**Technical Service Bulletin (TSB)**  
**Flash: Motor Control Processor B (MCP B) Updates 11A1**

<b>REFERENCE:</b>	<b>TSB:</b> 08-021-25 REV. B <b>GROUP:</b> 08 - Electrical	<b>Date:</b>	April 29, 2025	<b>REVISION:</b>	08-021-25 REV. A
<b>VEHICLES AFFECTED:</b>	<b>2024 (LB) Dodge Charger</b> This bulletin applies to vehicles equipped with 400V G2500 FR/RR Elec Drive Motors (Sales Code ELD).			<b>MARKET APPLICABILITY:</b>	<input checked="" type="checkbox"/> NA <input checked="" type="checkbox"/> MEA <input checked="" type="checkbox"/> SA <input checked="" type="checkbox"/> IAP <input checked="" type="checkbox"/> EE <input checked="" type="checkbox"/> CH
<b>CUSTOMER SYMPTOM:</b>	<p><b>Customers must experience a Malfunction Indicator Lamp (MIL) illumination and the vehicle must exhibit/set the following Diagnostic Trouble Code (DTC):</b></p> <ul style="list-style-type: none"> <li>• P1626-00 - Park Pawl Motor Stuck.</li> </ul> <p><b>The customer may comment on one or more of the following symptoms:</b></p> <ul style="list-style-type: none"> <li>• Wrench icon is illuminated on the Instrument Panel Cluster (IPC).</li> <li>• Turtle icon illuminated on the IPC.</li> <li>• Reduced power.<

**Fig. 3**  
#38 AGSM Fuse Location

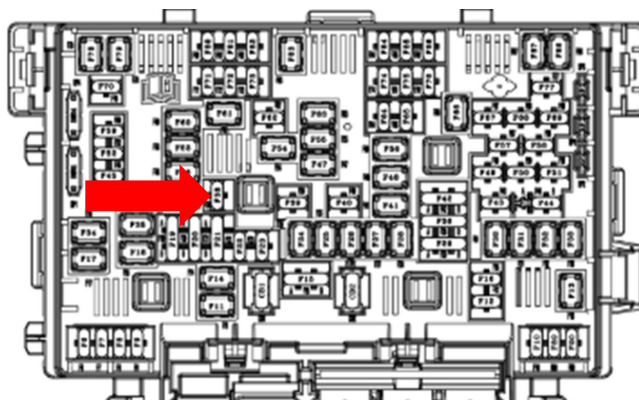
6. Remove the PDC cover, locate and remove the #38 AGSM fuse [Fig. 3](#).\*\*

24. \*\*Install the #38 AGSM fuse [Fig. 3](#) and the PDC cover [Fig. 2](#).
25. Position the rear carpet in place.\*\*
26. Connect the cooling fan wire harness connector [Fig. 1](#).
27. Install the front storage bin. Refer to the detailed service procedures available in DealerCONNECT/ ServiceLibrary under: Service Info> 23 - Body / Exterior / Bin, Storage / Installation.
28. Clear any DTCs that may have been set in any modules due to reprogramming. The wiTECH application will automatically present all DTCs after the flash and allow them to be cleared.
